Agenda
Crowley City Council
August 6, 2026
Work Session - 6:30 PM

1. Discuss and consider approval of a preliminary plat for Teeter Ranch, to create 189 residential lots and open space lots, requested by Steve Hawkins for an approximately 68-acre tract in the John W Haynes Survey, Abstract # 774 and the Memucan Hunt Survey, Abstract # 763, located at the southeast corner of Hampton Rd and FM 1187. Case # PPLT-2026-003
2. Discuss and consider approval to close all non-essential city operations for a half a day on September 10, 2026, to conduct our 2nd Annual Employee Co-Op.
3. Discuss and consider approval of a revised development plan for Karis Addition Phase 2A
4. Discuss tax rate calculations, and establish the proposed tax rate (take a record vote).

Presenter: Rachel Roberts	Meeting Date: August 6, 2026
Department: Community Development	Agenda Item: IV.3.
Subject: Discuss and consider approval of a revised development plan for Karis Addition Phase 2A

**Planning Review Comments
PD District Development Plan**

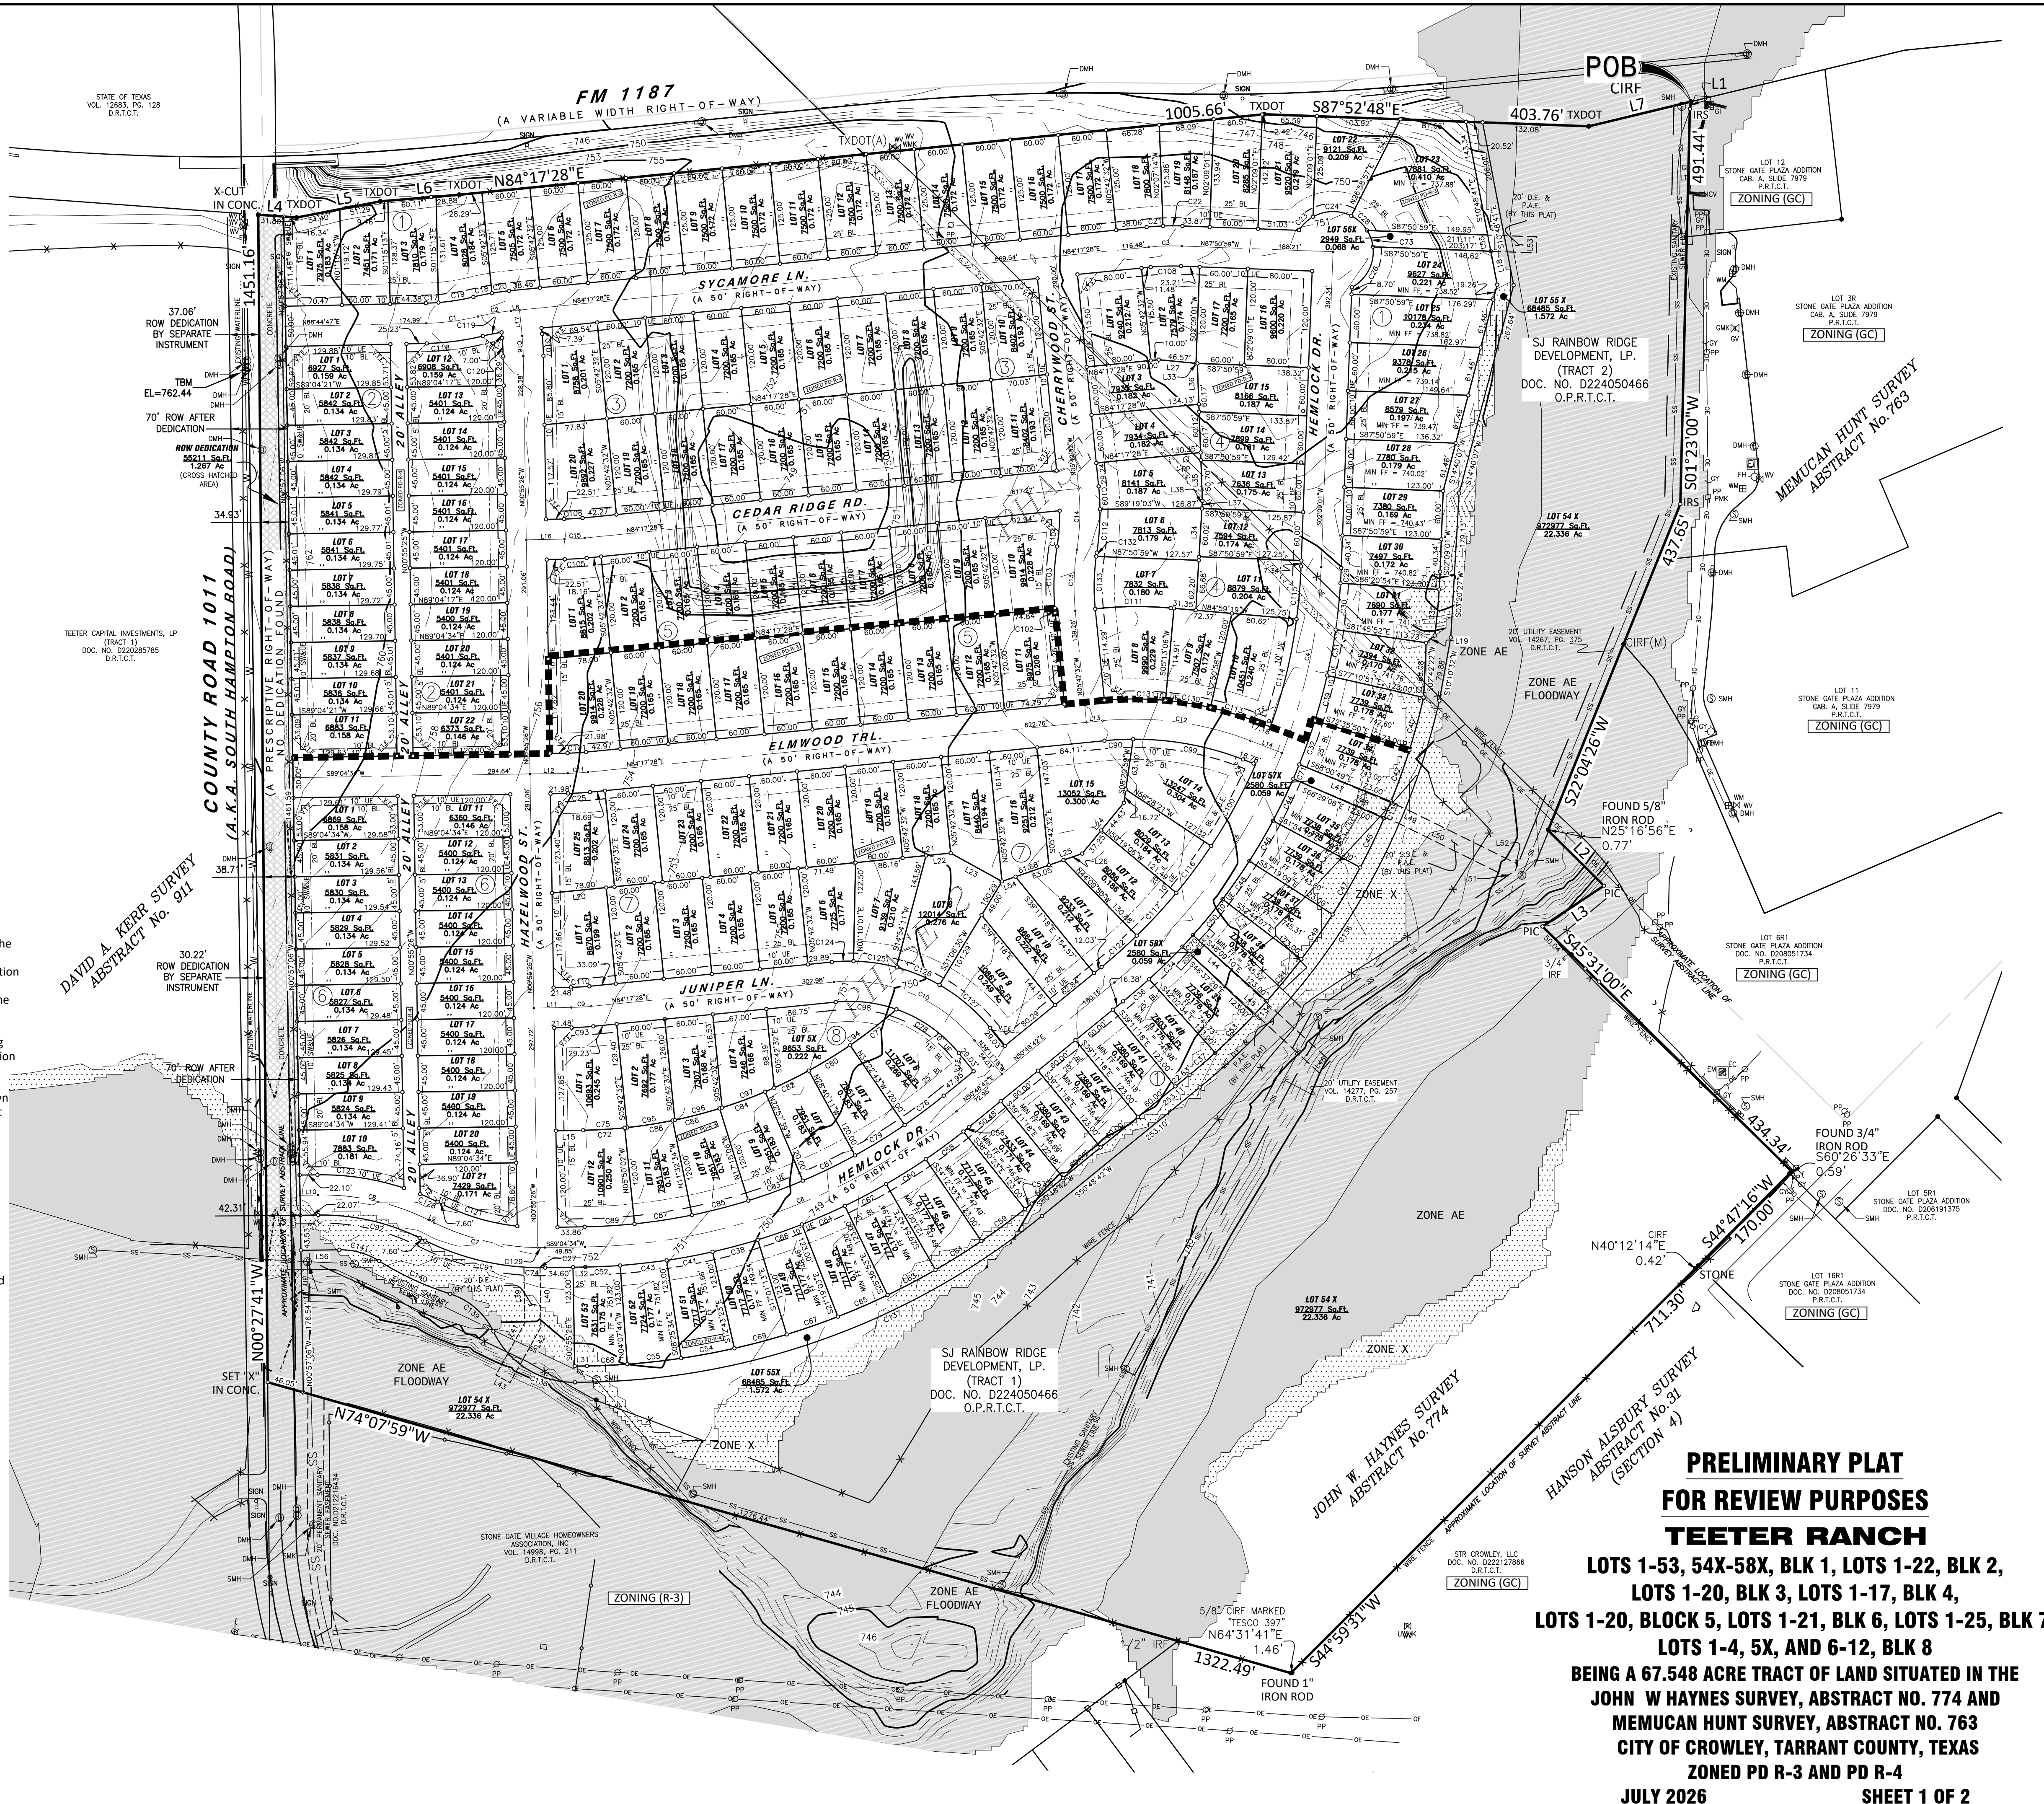
- Staff have reviewed the proposed park land dedication and determined that it meets requirements. Staff recommend approval of the dedication. However, the park land dedication shown on the plat drawing does not match the park land exhibit for consideration by the Parks Board. The requirement is 3 acres, and the area shown on the plat is approximately 1.6 acres. the plat drawing will need to be updated to match what is proposed in the park land dedication exhibit.

- The lot summary table on page 2 of the plat shows 5 open space lots. This number is actually six. The lots are shown correctly on the plat drawing; only the table has the error. This is a minor error that can easily be corrected.

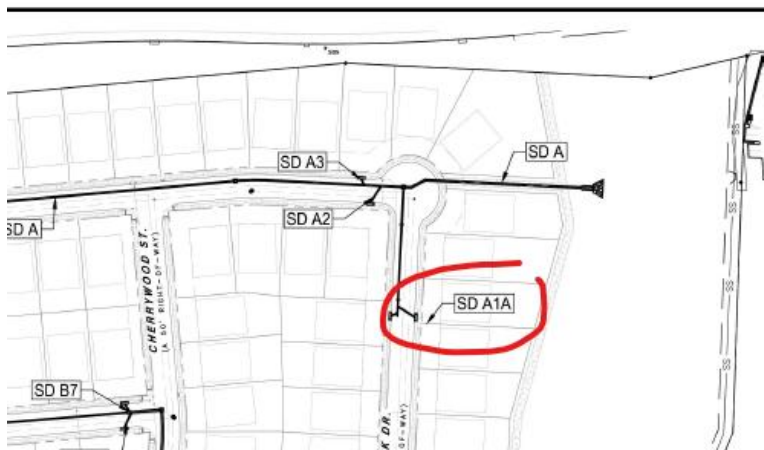
7. SHEETS C4.00-C4.11- There are multiple instances where the proposed sewer line is crossing above a proposed waterline. At these locations, a TCEQ-approved mitigation method per *Title 30, Texas Administrative Code, (30 TAC), Chapter 217, Rule §217.53* shall be indicated on the plans:

(ii) at least two nominal sizes larger than the wastewater collection pipe; and

(iii) supported by spacers between the collection system pipe and the encasing pipe at a maximum of five-foot intervals.

(B) A collection system pipe that crosses above a water supply pipe must be constructed of at least 150 psi pressure class, corrosion-resistant, non-brittle pipe and must use manufacturer-approved adapters. Gasketed joints, compression joints, and other non-bonded joints must be designed to seal at atmospheric pressure.

Partially addressed. The mitigation methods are shown, but multiple water crossings are violating the minimum cover requirement (60" below proposed grade).

C2U - MINOR COLLECTOR 2 LANE UNDIVIDED

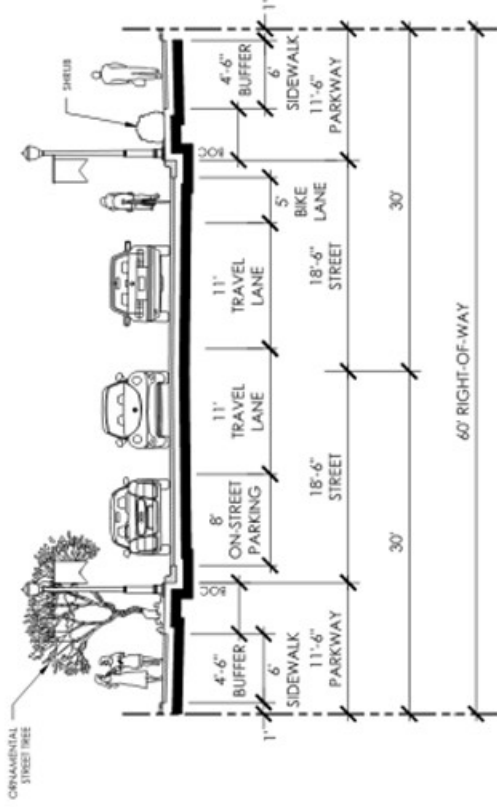
1. Previous comments on the sidewalk are not resolved. The sidewalk extension to the southern property line moves pedestrians onto Hampton Rd. to cross the creek.
2. City access requirements for park land have not been resolved. Mid-block ramps with bollards to access parkland have not been shown. We'll need two access points. Possible locations; Sycamore Ln. and Hemlock, Hemlock @ Elmwood Trl., Hemlock @ Hazelwood St.
3. I've attached an illustration of the Minor Collector description for Crowley. Your plan doesn't include a bike lane on the west side of Hampton. If you narrow the road lanes to 11.5' there would be room for the bike lane (southbound).

KARIS PHASE 2A
CITY OF CROWLEY
TARRANT COUNTY, TEXAS
TYPICAL PAVING SECTIONS

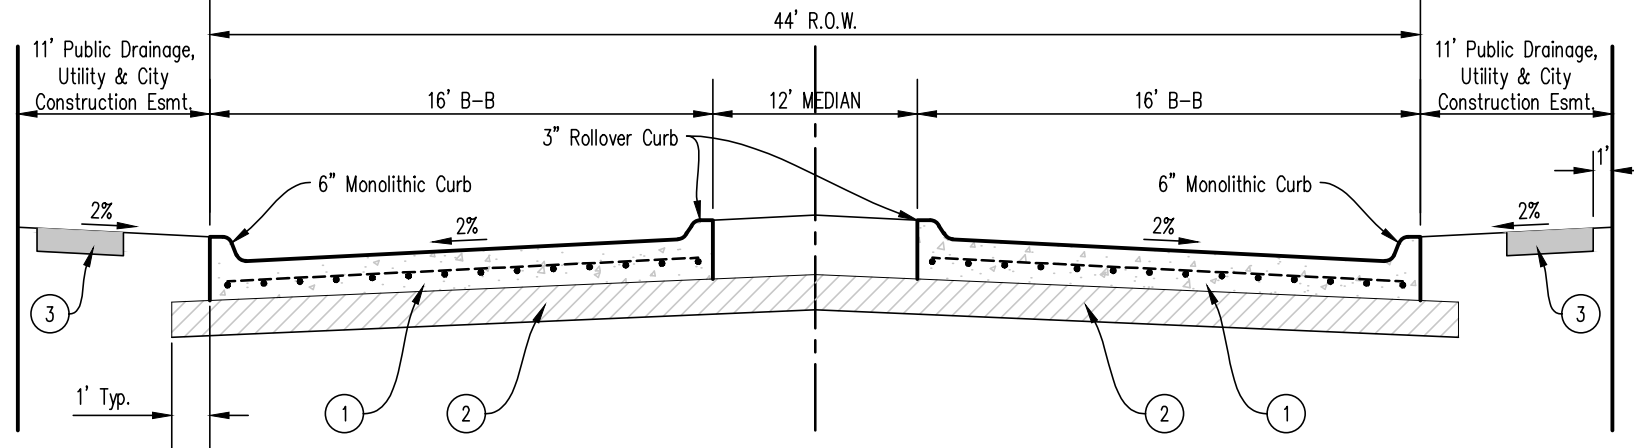
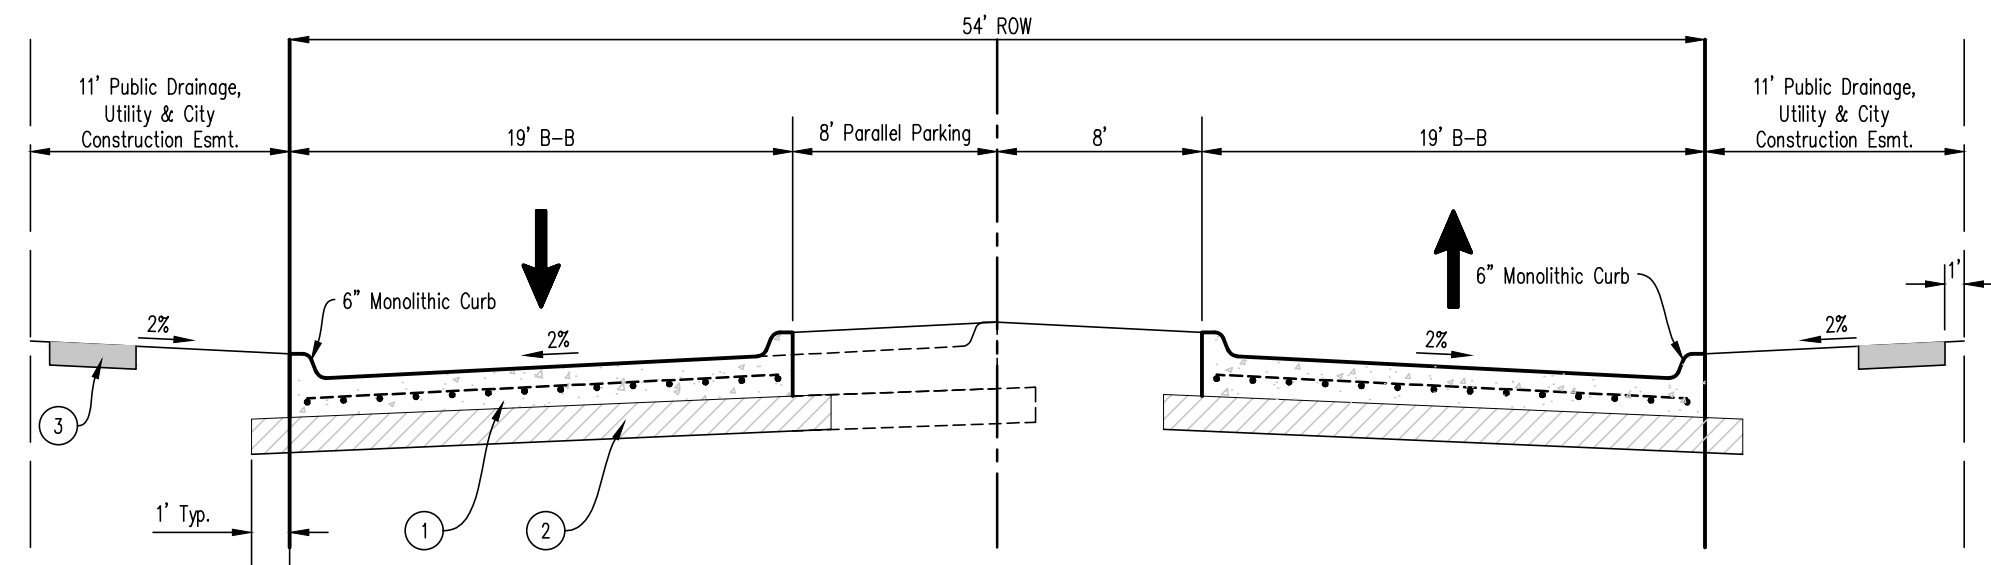
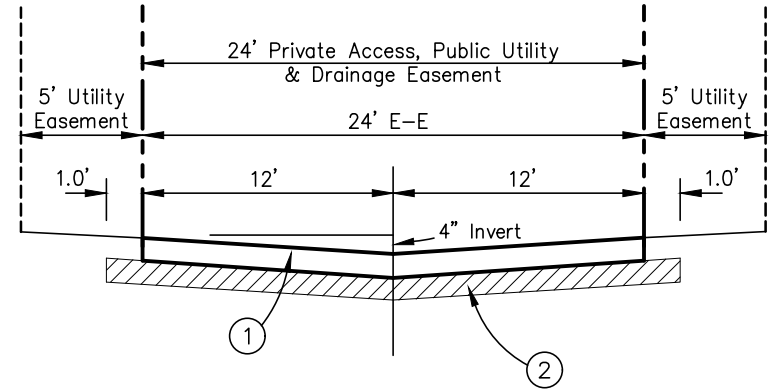
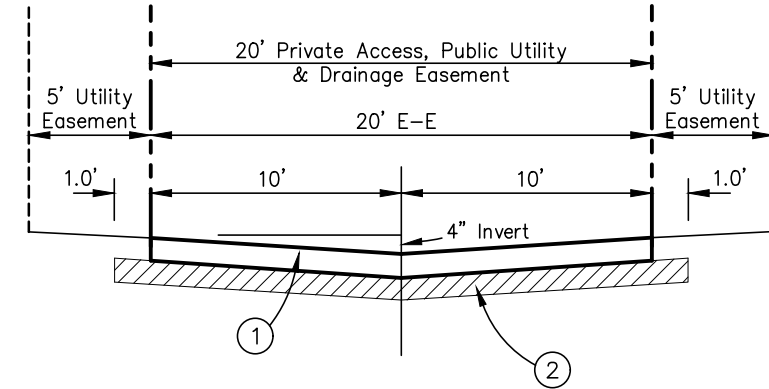
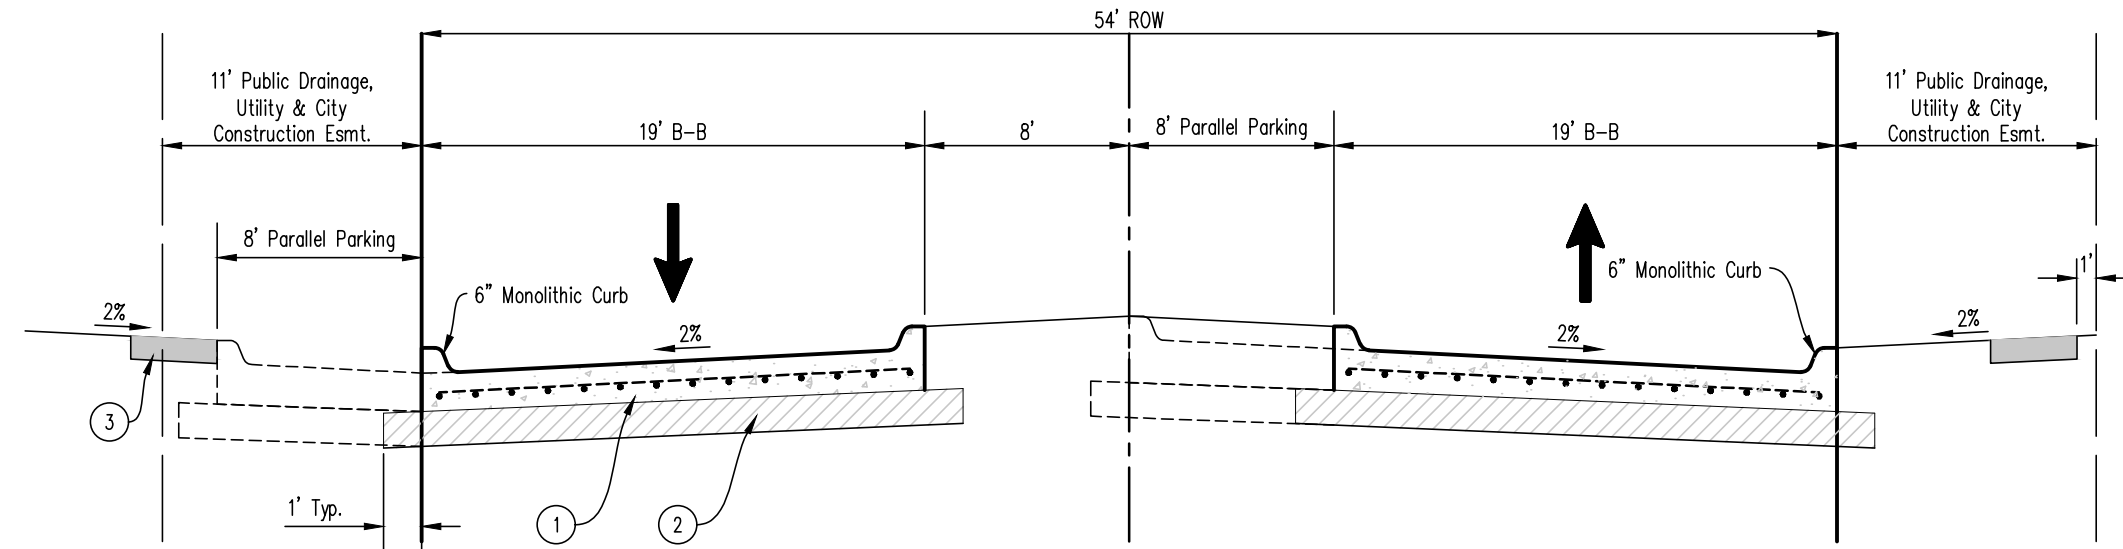
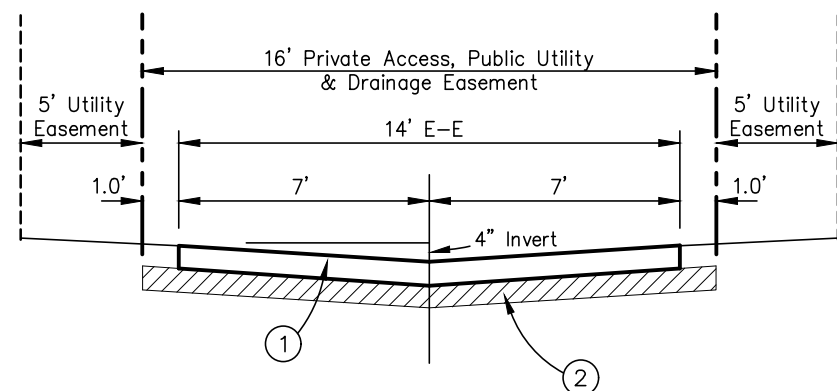
- 2) Sheet 3 – Blue Pansy Way (Snapdragon on the preliminary plat and in the landscape development plan) is not color-coded to show what type of ROW it is. Is it an alley?

RESPONSE: *The name has been updated to Blue Pansy Way (24’ Alley Mews), and it is now color coded based on the legend on the thoroughfare plan.*

STAFF RESPONSE: ADDRESSED.

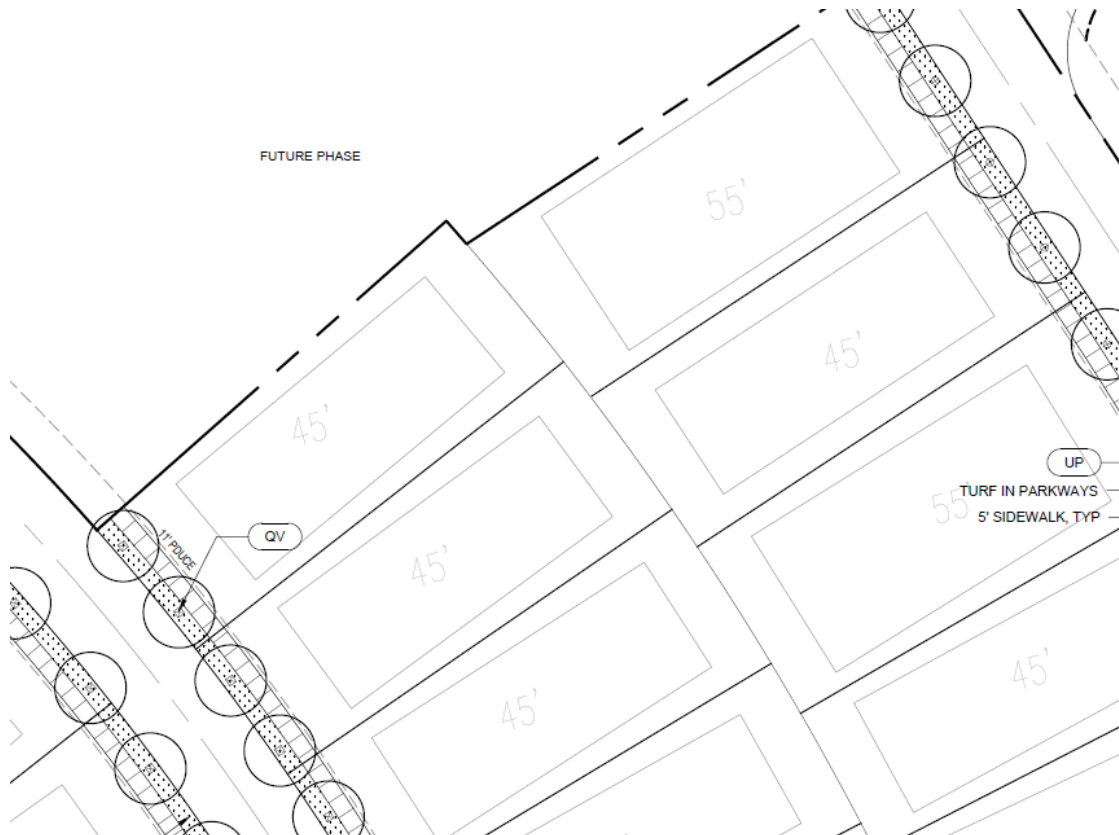
- 5) Previously, we had talked a pedestrian path being added across the Oncor line to connect this phase to the previous phase, but I don’t see that added on the development plan, although I do see an open space noted between Block E lots 31 and 23 on one side and 29 and 30 on the other. Will a trail be added in the open space? It’s noted on the plat as only a drainage and utility easement.

RESPONSE: *The 8' trail mentioned previously has been added to the preliminary paving plans and landscape plans per comment. The open space lot easement in Block E (5) has been relabeled as an Access, Drainage, and Utility Easement on the preliminary plat.*

STAFF RESPONSE: ADDRESSED, but please provide documentation of approval from Oncor to continue the trail across the Oncor easement to connect with the existing Phase 1A.
